Felix Buechi *et al.*
Appl. No.: 10/608,088

Amendments to the Drawings:

REMARKS/ARGUMENTS

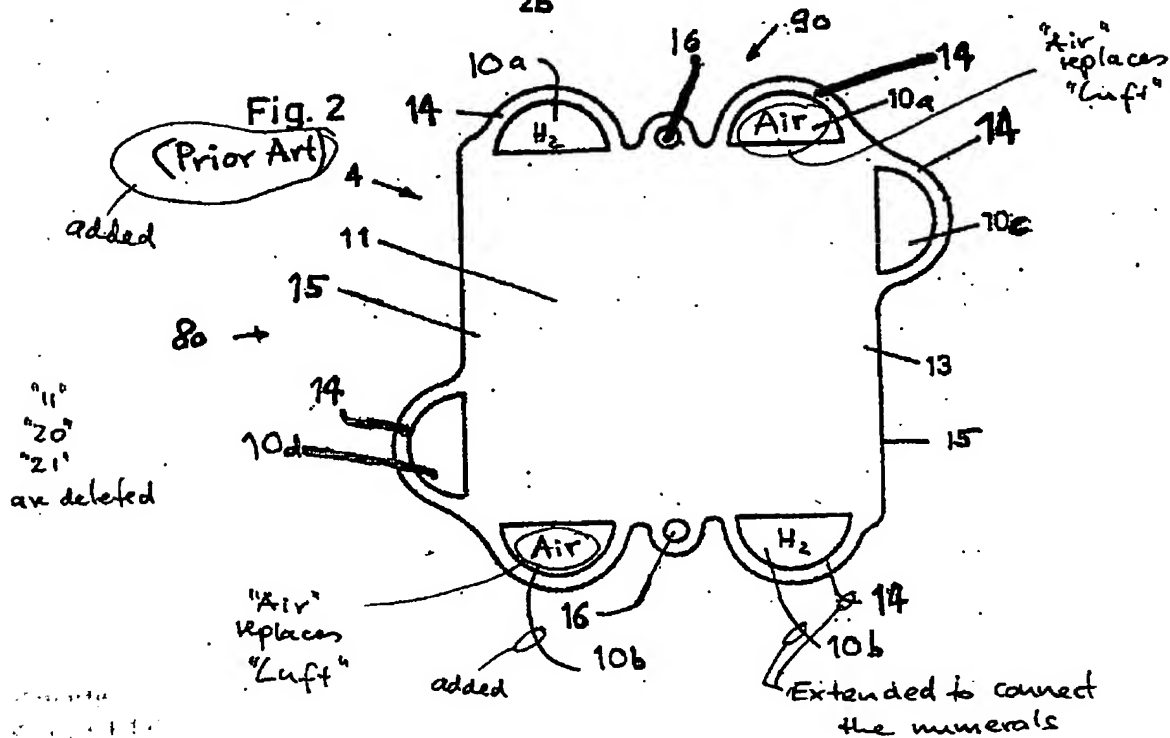
The Examiner objects to the drawings under 37 C.F.R. §1.84(p)(5) for showing reference numerals not mentioned in the description, and under 37 C.F.R. §1.84(p)(4) for improperly using reference numerals for different items. Further, the Examiner requests labeling Figures 1 and 2 as Prior Art.

Figure 1 has been labeled as “Prior Art.” Further, in Figure 1, reference numerals 20 and 21 have been deleted.

In Figure 1, reference numerals 20 and 21 have been deleted.

Further, Figures 1 and 2 have been labeled as "Prior Art."
